Response to Staff Comments

RE: *Popeyes Louisiana Kitchen – Restaurant with Drive-Thru – 1431 S Crismon Road,
Parcel No. 20081402A*

This Letter is to acknowledge and respond to comments detailed in your MEMORANDUM dated 12/10/2015 regarding the above mentioned project. Copies of your comments and this letter have been distributed to the project owner and the relevant consultants.

SD100

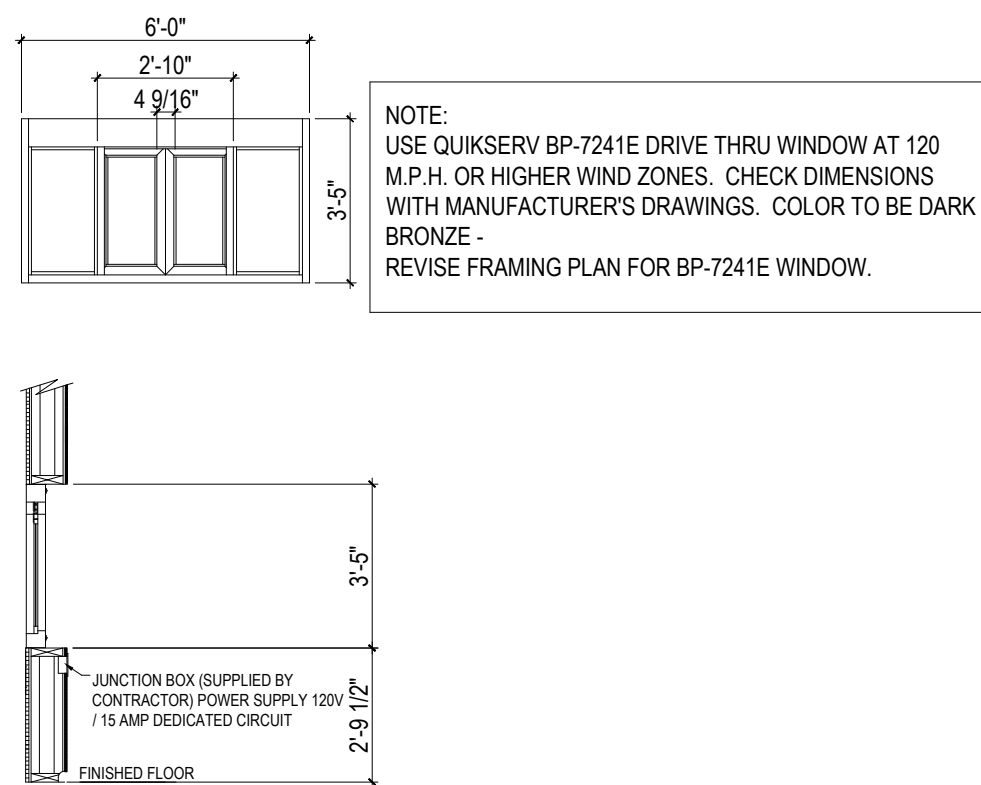
- d. The proposed site plan eliminates the existing pedestrian connectivity from the Crismon Road Sidewalk to the Home Depot store front. Provide a modified path to maintain the pedestrian link.

- i. **RESPONSE: Please see the site plan for this modification has already been addressed, see SD100 and reference keynote 10 for the location of the accessible pathway.**

LEFT & RIGHT EXTERIOR ELEVATIONS

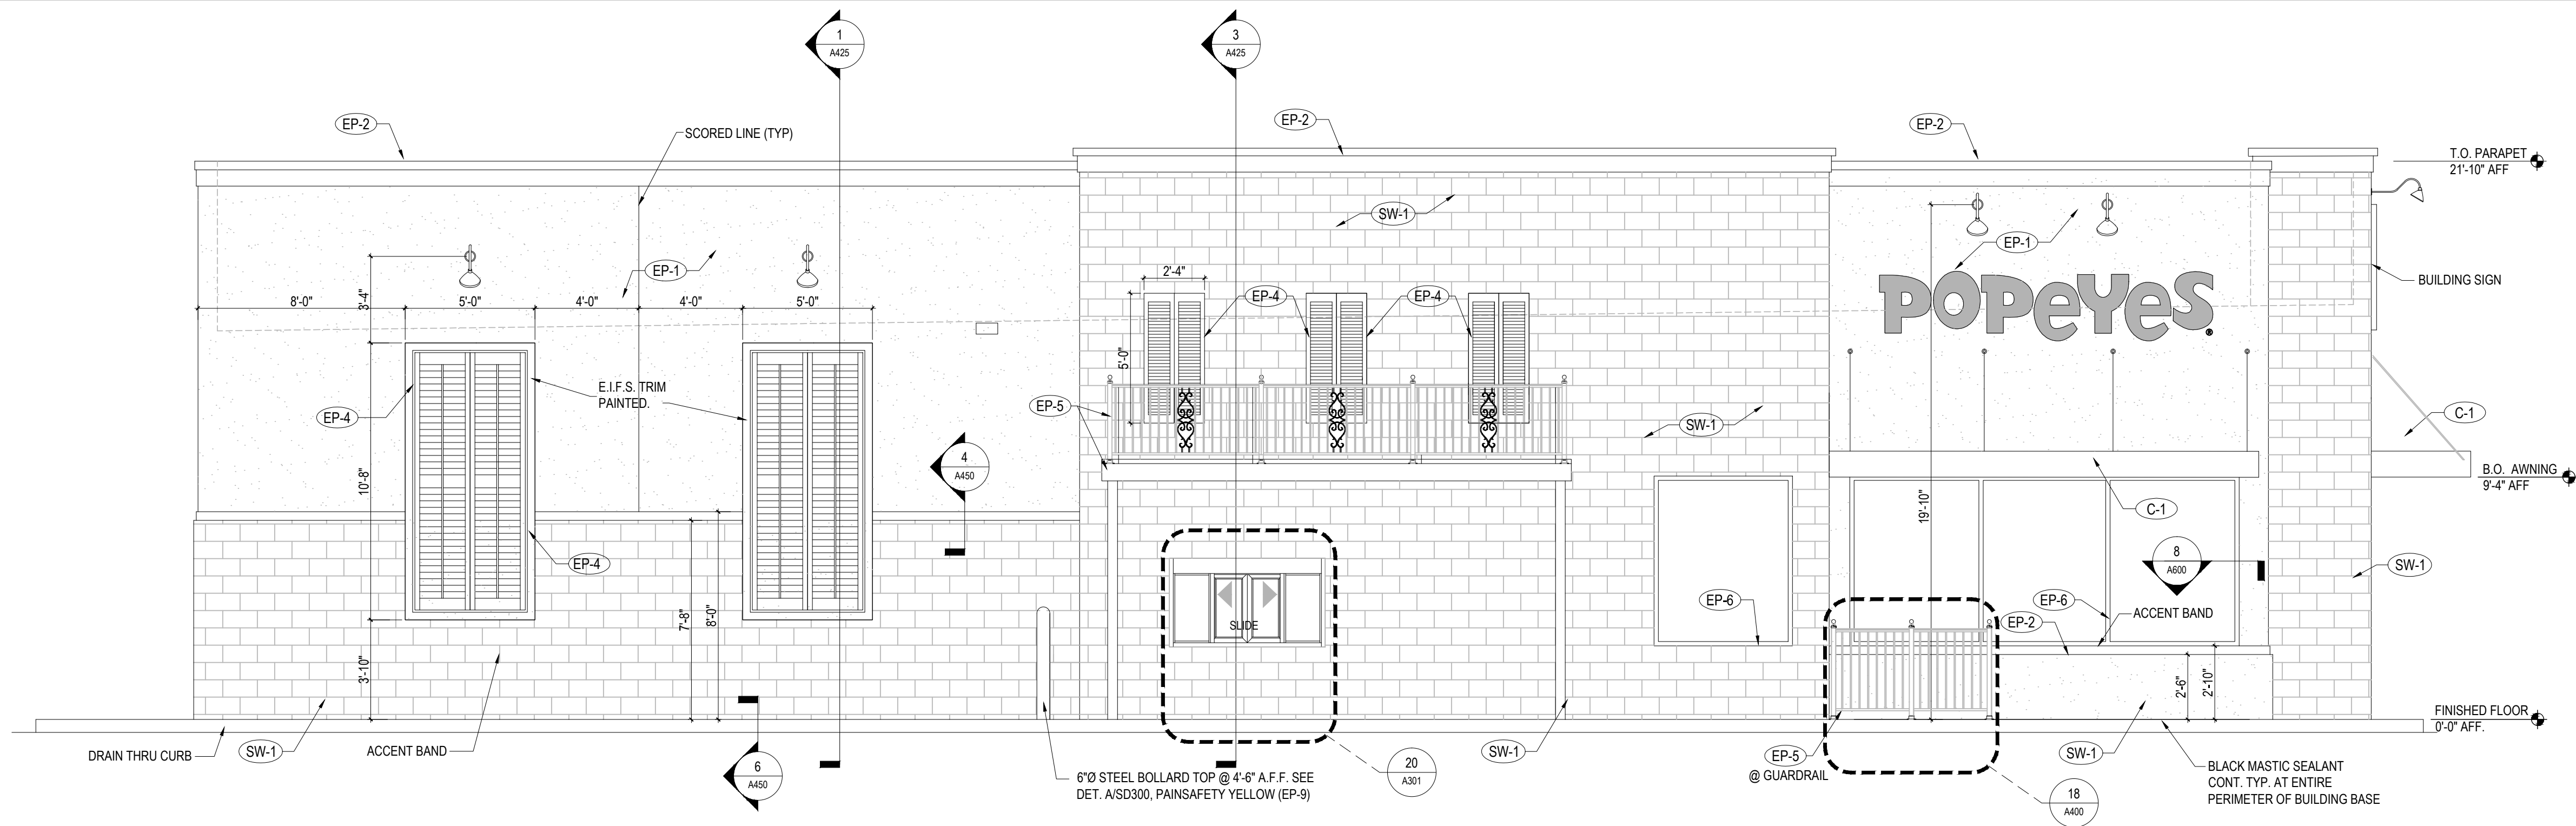
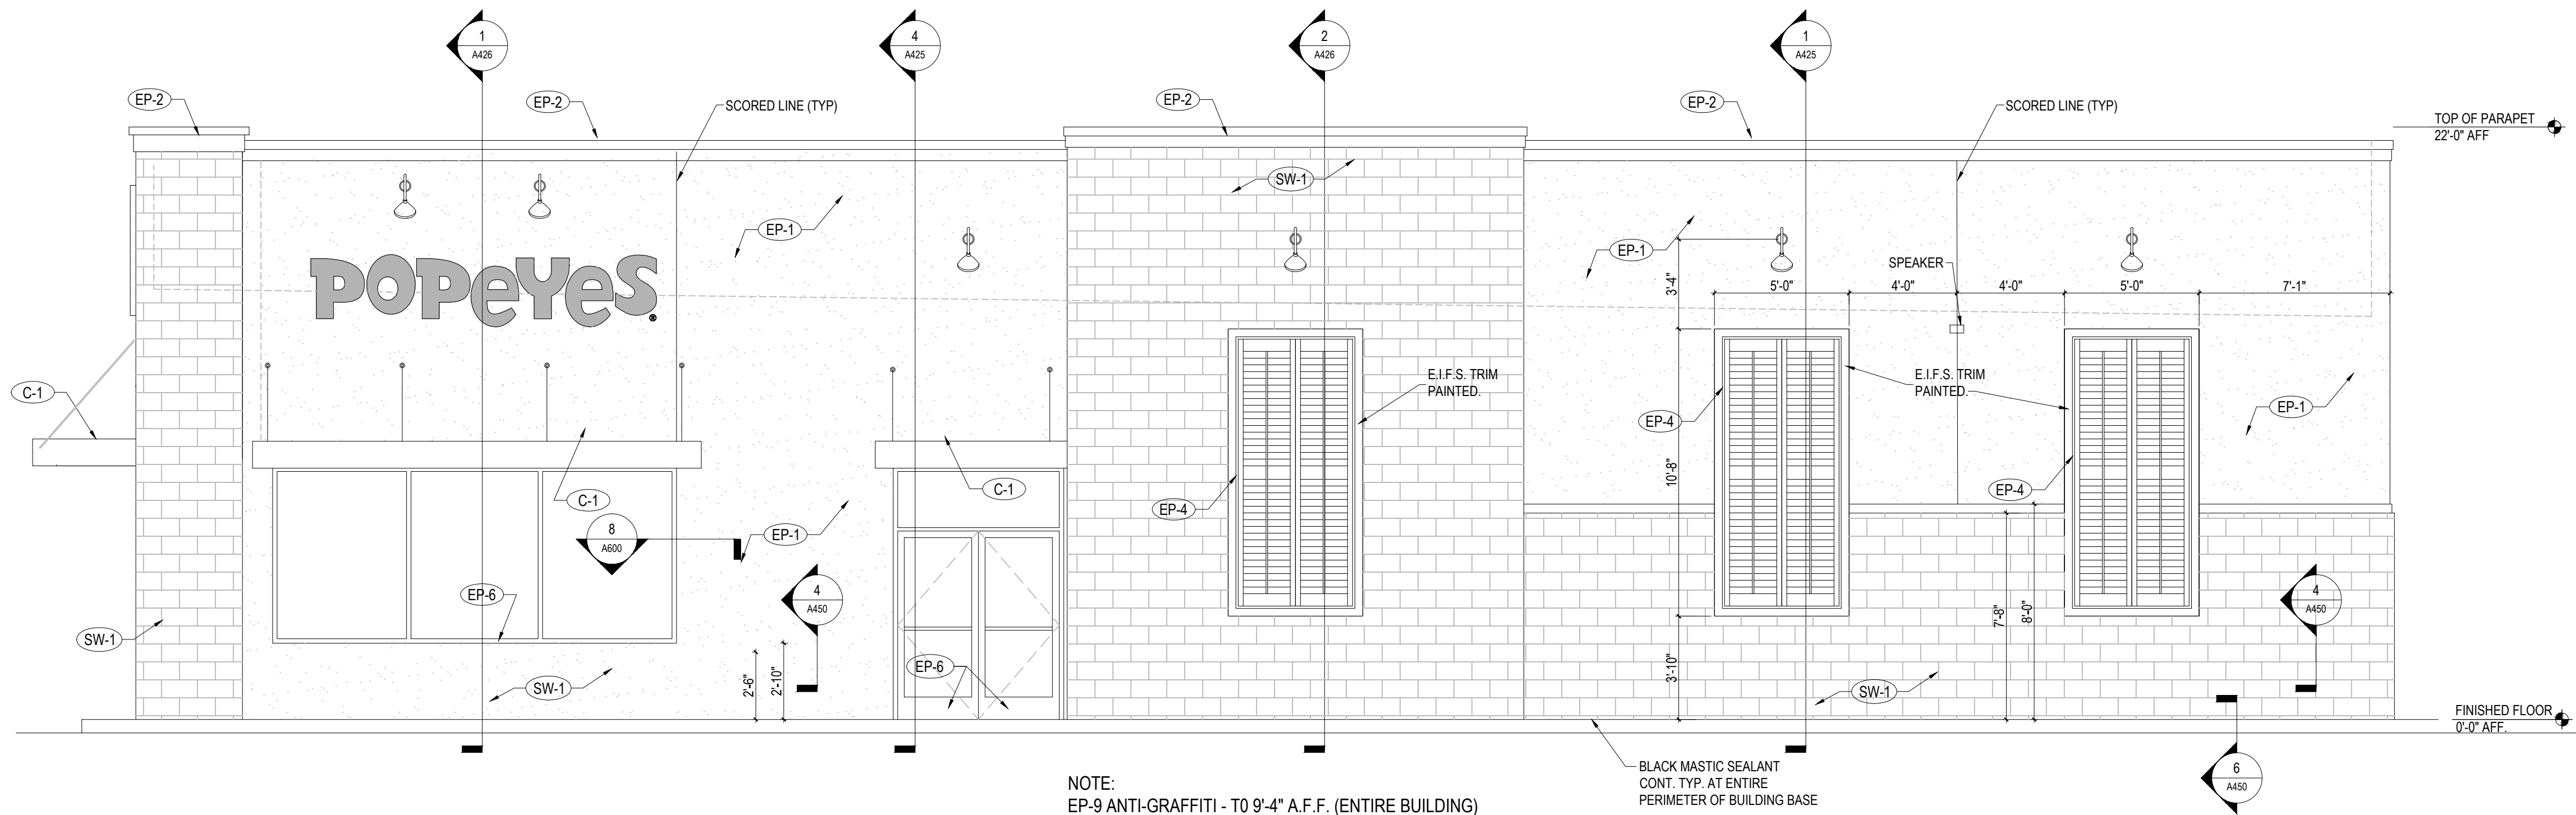
- 1. Replace standing seam canopy with more appropriate design elements like balcony with iron work railing similar to proposed one over pickup window

- 2. Replace ElDorado stones with more appropriate one that belongs to the design theme, also remove stone wainscot.

- 3. Vary parapet height

- 4. East elevation of the building faces Home Depot and drive thru customers, therefore it needs enhancement with more appropriate architectural details.

- a. **RESPONSE: We eliminated the standing seam canopy and in its place are using flat awnings with cables, see revised elevations.**

- a. **RESPONSE: We replaced the stones with another stone, also from the manufacturer El Dorado, see physical sample. We removed wainscot, see elevations.**

- a. **RESPONSE: we adjusted the parapet to create a more dynamic façade, see elevation**

- a. **RESPONSE: We added architectural elements to the East elevation, stone to 8' and a shutter to match the rest of the building.**
